UNITED STATES PATENT AND TRADEMARK OFFICE

APPLICATION NO.	FILING DATE	FIRST NAMED INVENTOR	ATTORNEY DOCKET NO.	CONFIRMATION NO.
10/573,061	03/21/2006	Raanan Ben-Horin	7031P017	6568
8791 7590 03/20/2009 BLAKELY SOKOLOFF TAYLOR & ZAFMAN LLP 1279 OAKMEAD PARKWAY SUNNYVALE, CA 94085-4040				
EXAMINER				
ANDERSON, DENISE R				
ART UNIT		PAPER NUMBER		
1797				
MAIL DATE		DELIVERY MODE		
03/20/2009		PAPER

Office Action Summary

DETAILED ACTION

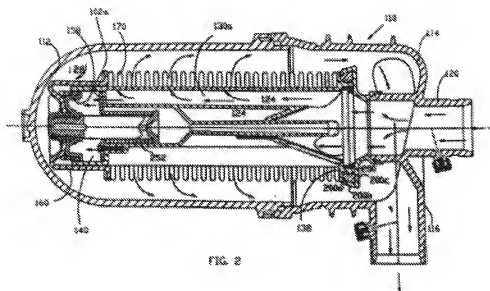
6. Claims 1 and 3-6 are rejected under 35 U.S.C. 112, first paragraph, as failing to comply with the written description requirement. The claim(s) contains subject matter which was not described in the specification in such a way as to reasonably convey to one skilled in the relevant art that the inventor(s), at the time the application was filed, had possession of the claimed invention. Claim 1 recites "to initially force the split ring against the planar radial wall." No support can be found for this limitation in the specification, the original claims, or the drawings.

The examiner will interpret this to mean that the split ring is located adjacent the planar radial wall as shown in applicant's Figure 2.

Applicant's Figure 2

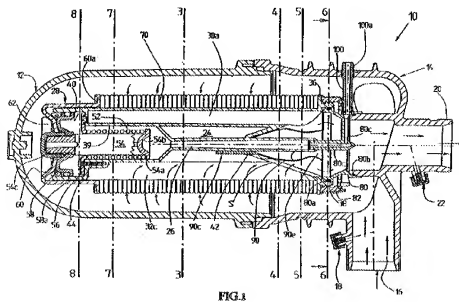
12. The patentability analysis will begin with a comparison of applicant's Figure 2 to that of Sadan et al.'s Figure 1.

A table appears below, keying applicant's claimed structure to that of Sadan et al.

<i>Recited Structure</i>	<i>Recited Structure Support</i>	<i>Sadan et al. Structure</i>
Filtering device	Filter device 10 in Fig. 1. Ref. no. 110 in Fig. 2.	Filter device 10 in Fig. 1.
Housing	Housing member 114 in Fig. 2.	Housing member 14 in Fig. 1.
Inlet port	Ref. no. 120 in Fig. 2.	Port 20 in Fig. 1.
Outlet port	Ref. no. 116 in Fig. 2	Port 16 in Fig. 1.
Core member	Core member 124 in Fig. 2.	Core member 24 in Fig. 1.
Abutment ring	Ring 138 in Fig. 2.	"[A] fixed element backing flange 36, combined with mounting screw-threaded ring 38," col. 3, lines 18-19.
Filter member	Filtering disks battery 170 in Fig. 2.	Filer disks battery 70 in Fig. 1.
Piston assembly	Piston assembly 28 in Fig. 1. Ref. no. 128 in Fig. 2.	Piston system assembly 28 in Fig. 1.
Piston	Piston 158 in Fig. 2.	Piston 58 in Fig. 1.
Displaceable member	Spring 252 in Fig. 2.	Spring 52 in Fig. 1.
Assembly		
Seat member=Trough	Seat member 200 in Fig. 2.	Top of mounting fitting 80 and ring 82 in Fig. 1.

Circular rim	Circular rim 200a in Fig. 2.	Circular rim at bottom of ring 82 in Fig. 1.
Cone-shaped wall	Cone-shaped wall 200b in Fig. 2.	Cylinder-shaped wall of ring 82 in Fig. 1.
Radial wall	Radial wall 200c in Fig. 2.	Radial wall at top of ring 82 in Fig. 1.
Split ring	Ring 202 in Fig. 2.	Threaded portion of ring 82 in Fig. 1.

Sadan et al. Figure 1

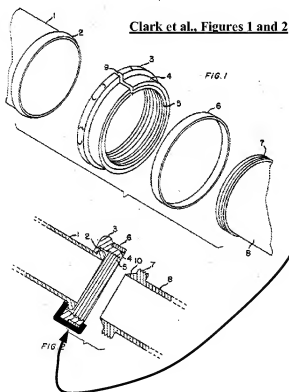
structure is analogous to that of Sadan et al. with one difference. Applicant's split ring and seat member are separable and Sadan et al.'s split ring and seat member are integrated, as shown in the figures below. Also shown below is the separable split ring (nut body portion 3 and ring portion 4) and seat member (rim 2 and collar 6) taught by the secondary reference, Clark et al. And finally, a schematic is provided to illustrate the location of the seat member's cone-shaped wall, radial wall, and circular rim, whether the seat member is applicant's or the prior art's.

Seat member
With integral split ring
With separable split ring

14. To summarize the claim 1 patentability analysis, Sadan et al. discloses the claimed invention except that the split ring and seat member are integrated, as opposed to separable.

Clark et al. teaches the separable split ring and seat member. It would have been obvious to one having ordinary skill in the art at the time the invention was made to have made the Sadan et al. split ring and seat member separable as taught by Clark et al., since Clark et al. states at Column 1, lines 32-44, that such a modification provides a way to join two pipe-like structures, like the recited inlet port and filter member of claim 1.
